ADDENDUM NO. 03

Project: Jim Hinkle Spring River
State Fish Hatchery Renovations
Mammoth Spring, Arkansas

The Contract Documents dated April 23, 2021, are hereby amended as follows:

TANK LAYOUT & DETAILS

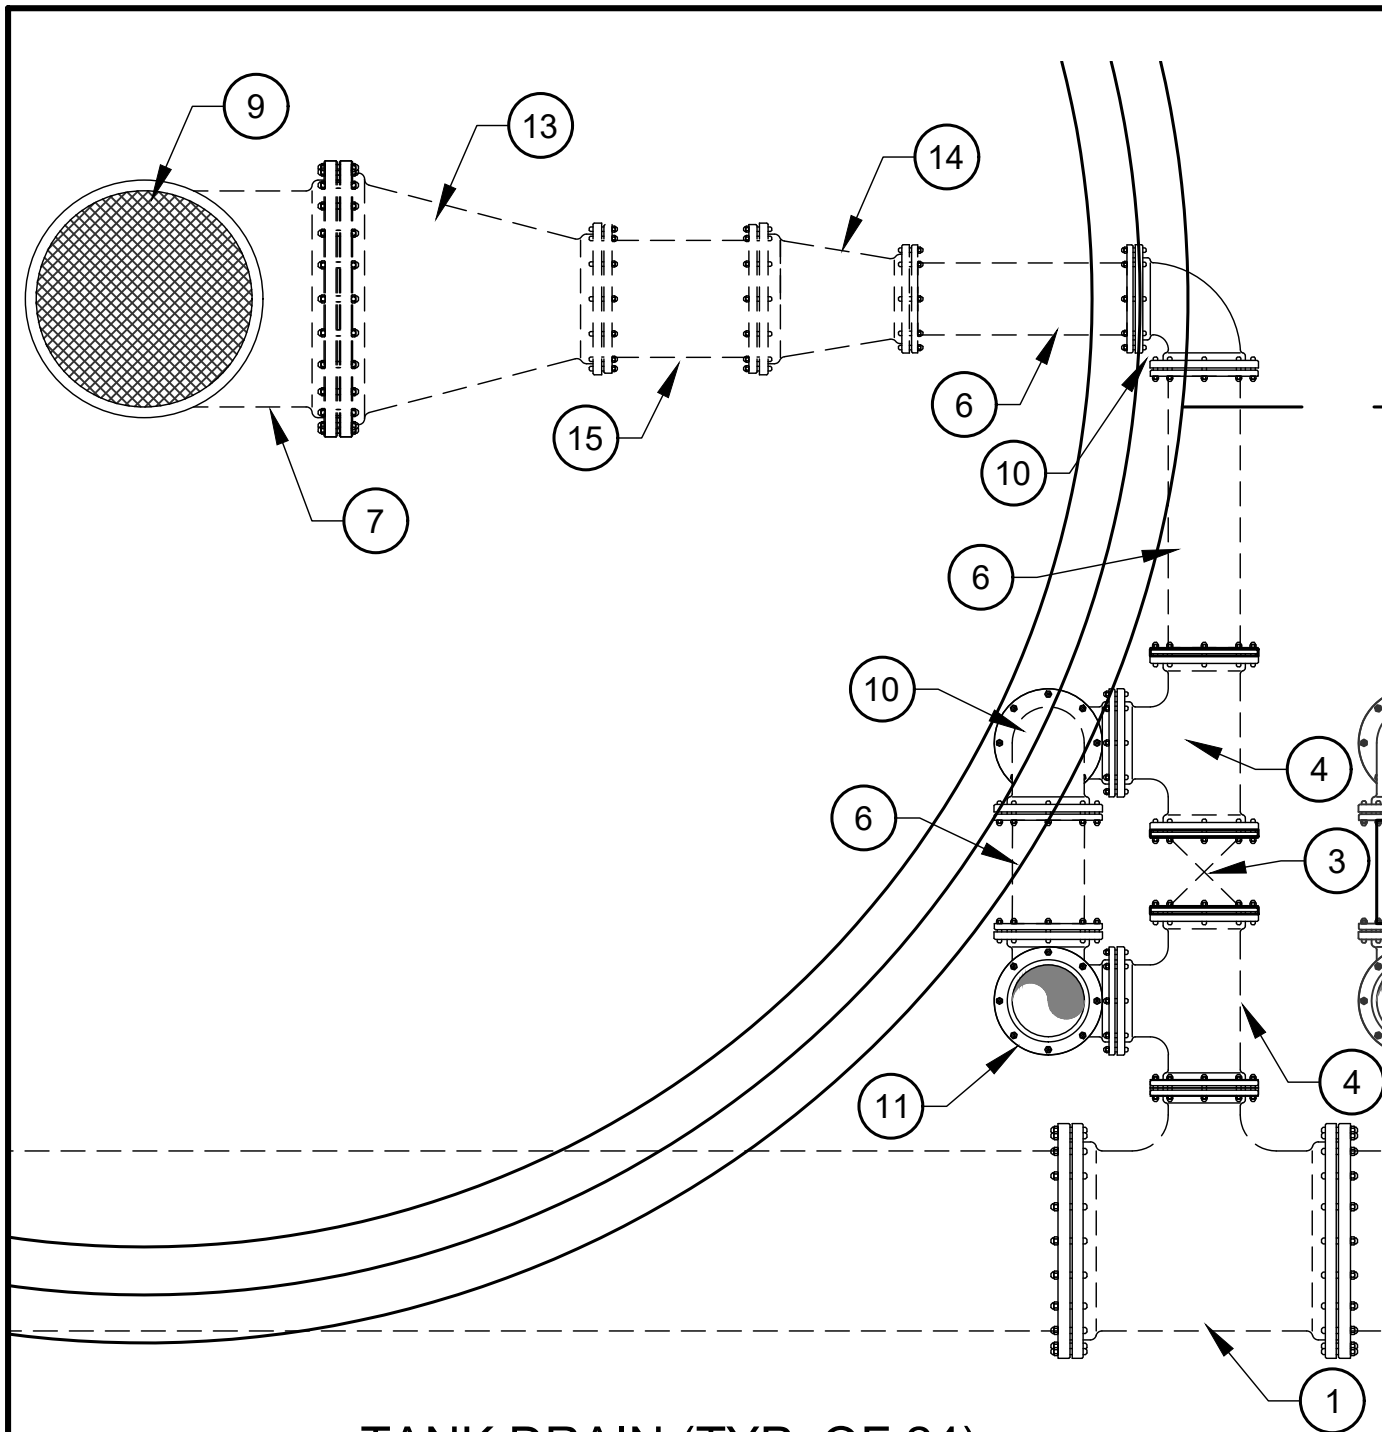
1. Sheet No. 02 – Tank Layout and Details:
 - a. Remove this sheet from the plans and replace with the following attached hereto:
 - i. Tank and Layout Details – Addendum No. 03
2. Sheet No. 03 – Fish Silo Plan and Piping Detail 1:
 - a. Modify the Plan as shown on Plan Tank Drain (Typ. of 24) – Addendum No. 03 attached hereto.
 - b. Modify the Plan as shown on Telescoping Valve and Piping – Addendum No. 03 attached hereto.
3. Sheet No. 04 – Fish Silo Plan and Piping Detail 2:
 - a. Modify the Tank Section with North Tank Section – Addendum No. 03 attached hereto.

PLUGGING EXIST. 12" PVC (TYP OF 36)

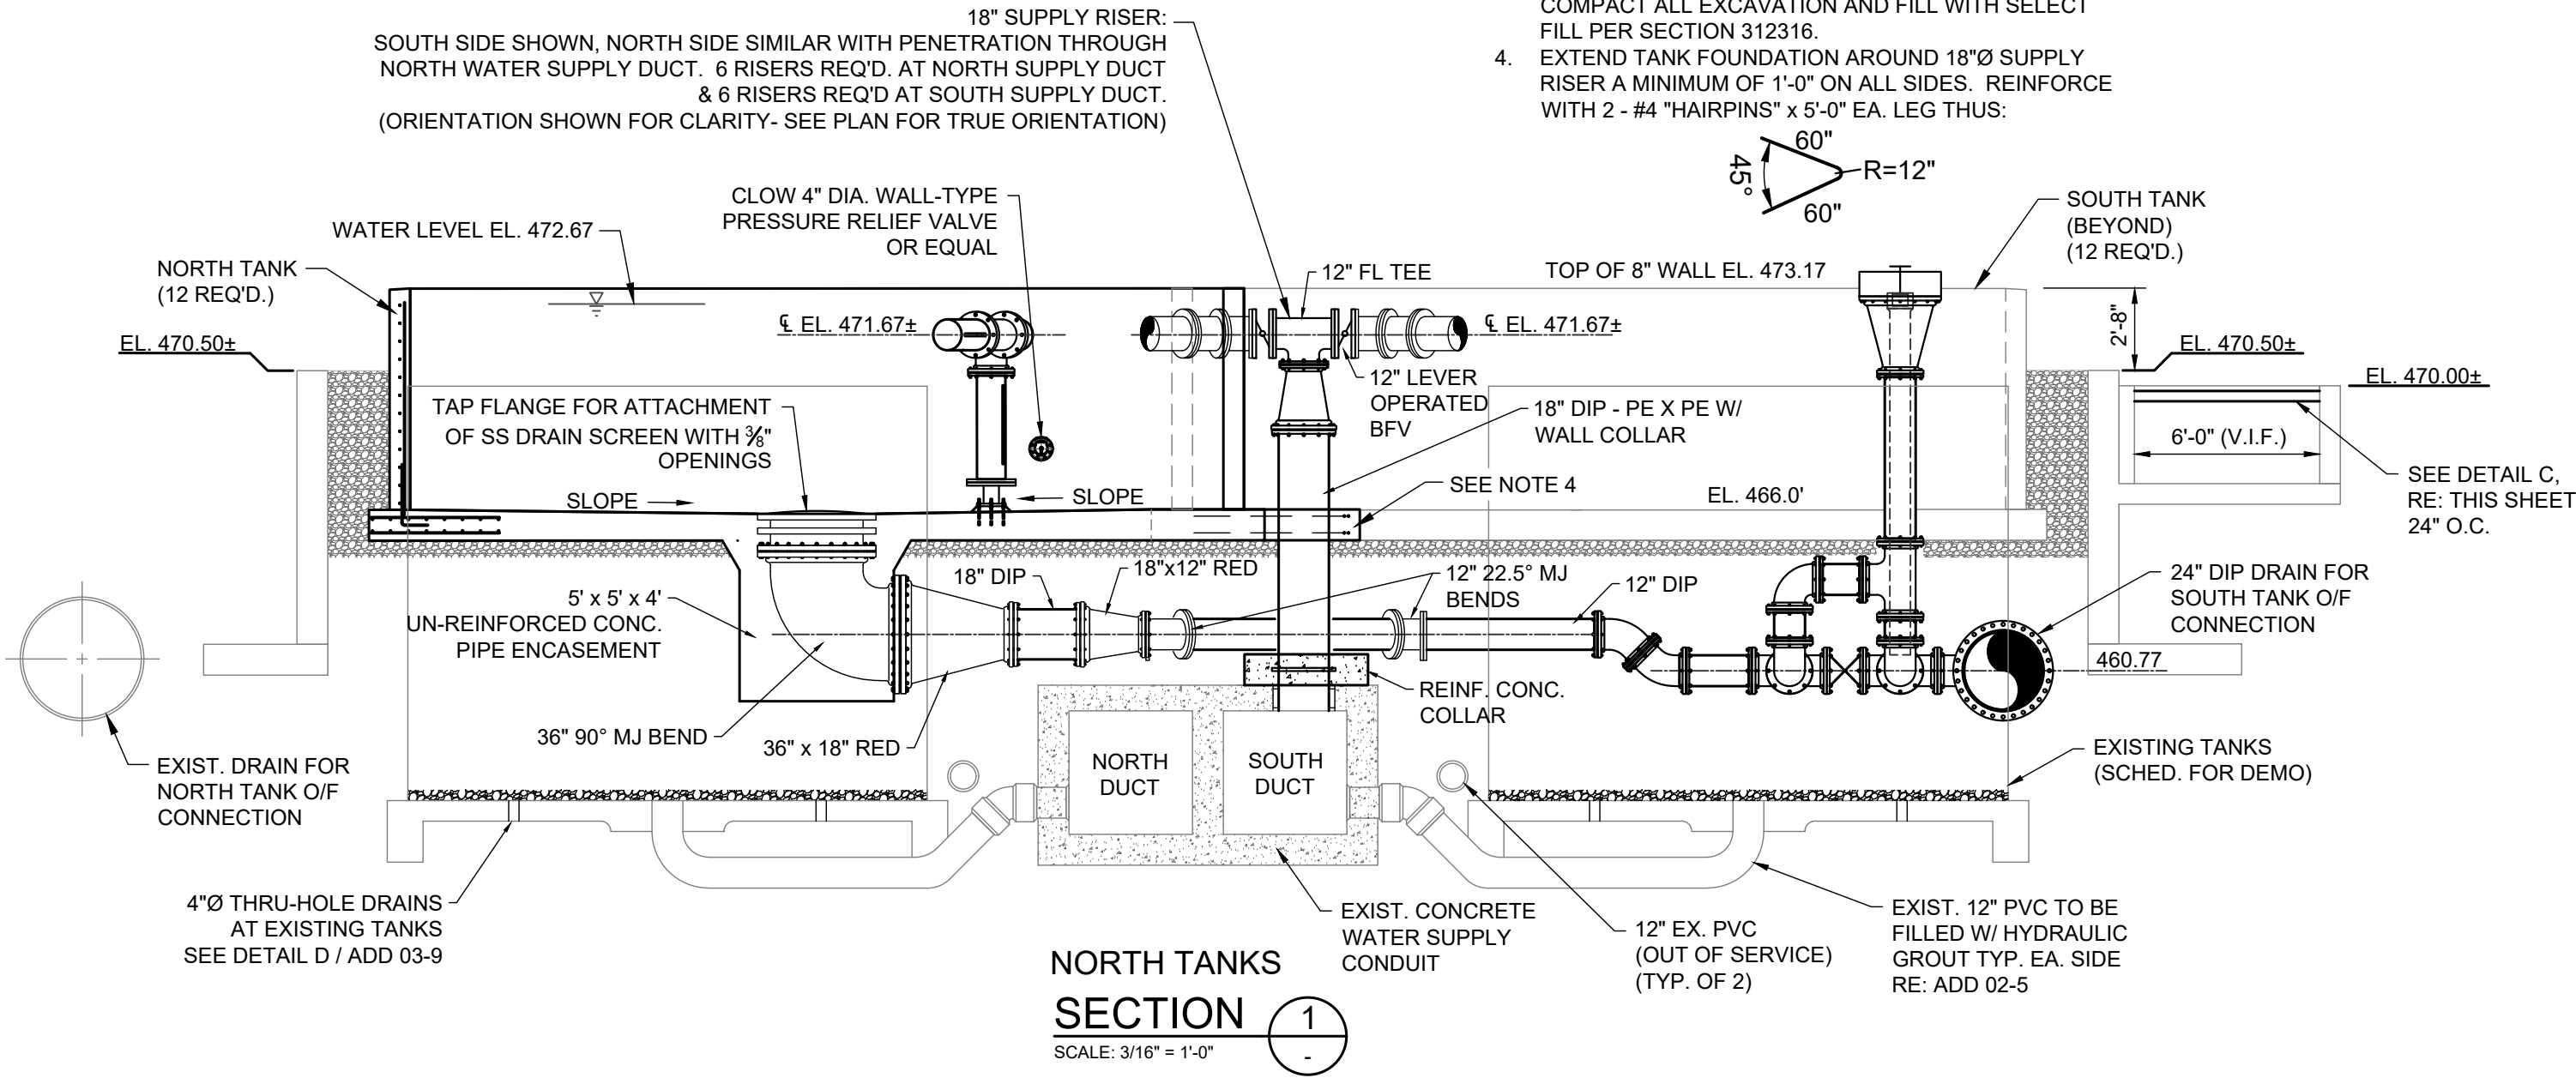
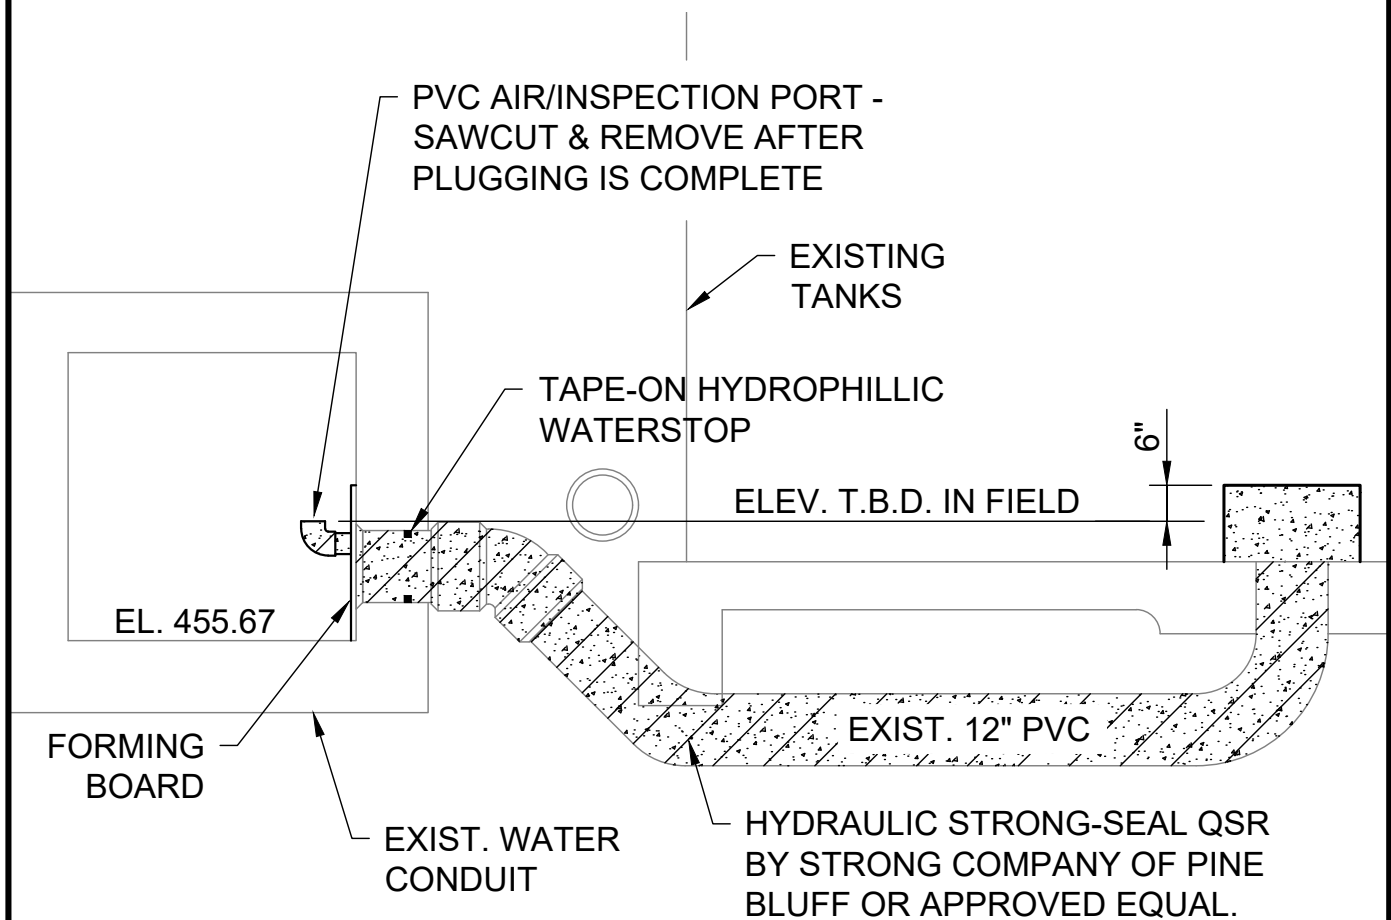
- b. Add the following detail to the Sheet
 - i. "Plugging Exist. 12" PVC (Typ of 36) – Addendum No. 03"
 - ii. "Link Seal – Addendum No. 03"
 - iii. "Drain Encasement (North Tanks) – Addendum No. 03"
 - iv. "Drain Encasement (South Tanks) – Addendum No. 03"
 - v. "Drains at Existing Tanks (36 REQ'D) – Addendum No. 03"
 - vi. "South Tanks – Section 1 – Addendum No. 03"
